PERMIT

SEWAGE DISPOSAL SYSTEM
HOWARD COUNTY HEALTH DEPARTMENT
BUREAU OF ENVIRONMENTAL HEALTH
410-313-2640

P 514183
A 49889-R

SUBDIVISION Harless Manor LOT NUMBER 24 ADDRESS 14004 Monticello Drive

corner septic area
NOT TO SCALE

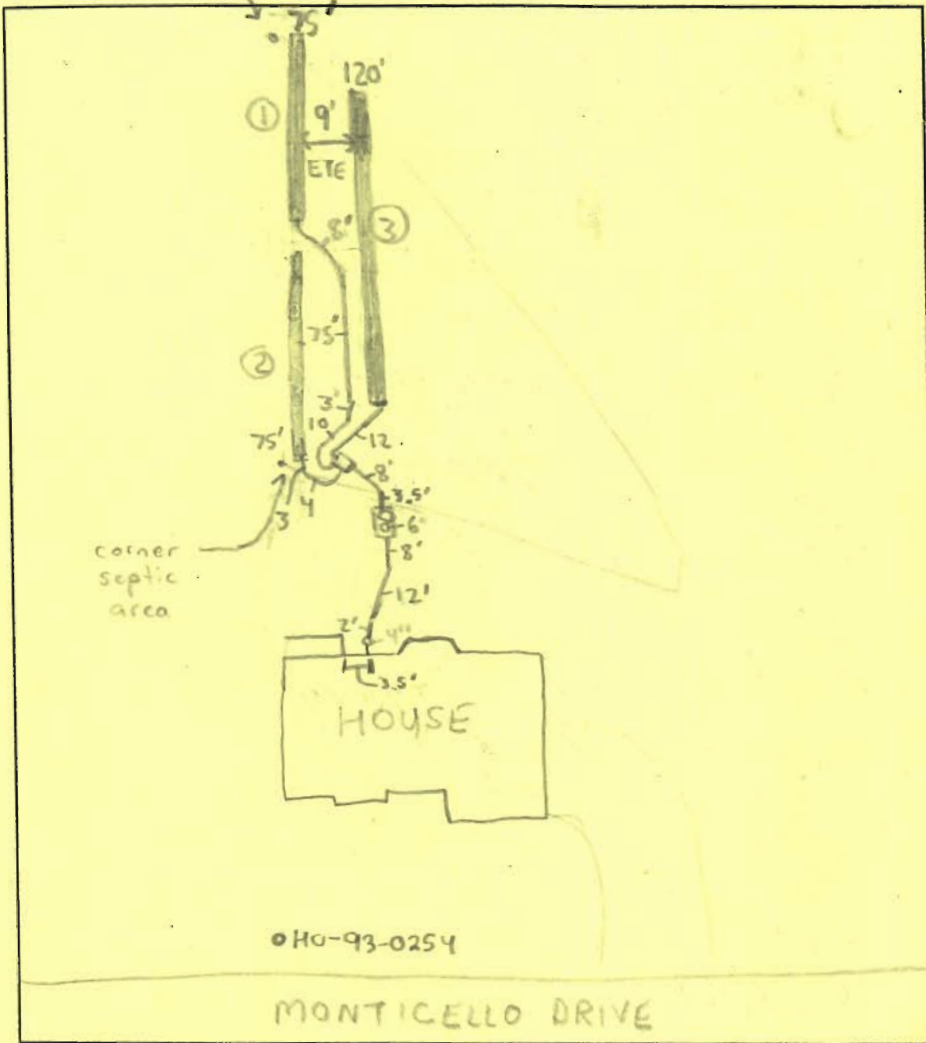
PRE-CONSTRUCTION INSPECTION: CONTOUR SLIGHTLY DIFFERENT THAN SHOWN ON PLAN, BOX AND TRENCH LAYOUT ADJ. TO AVOID LARGE LOSS OF UPPER LEFT SEPTIC EASEMENT CORNER

INSPECTION COMMENTS: 8/14/00 - OK TO CONTINUE WORK, RUN TRENCHES AS LONG AS POSSIBLE TO MAXIMIZE END OF SDA, KEEP TRENCHES 9' ETE (SRW) 8/14/00 - OK TO COVER TRENCH (1) & (2) AND CONTINUE WORK (SRW) 8/15/00 - OK TO CONTINUE WORK (SRW)

EVENTUAL REPAIR MAY INVOLVE SETTING NEW DBOX AND RUNNING TRENCHES AS SUCH
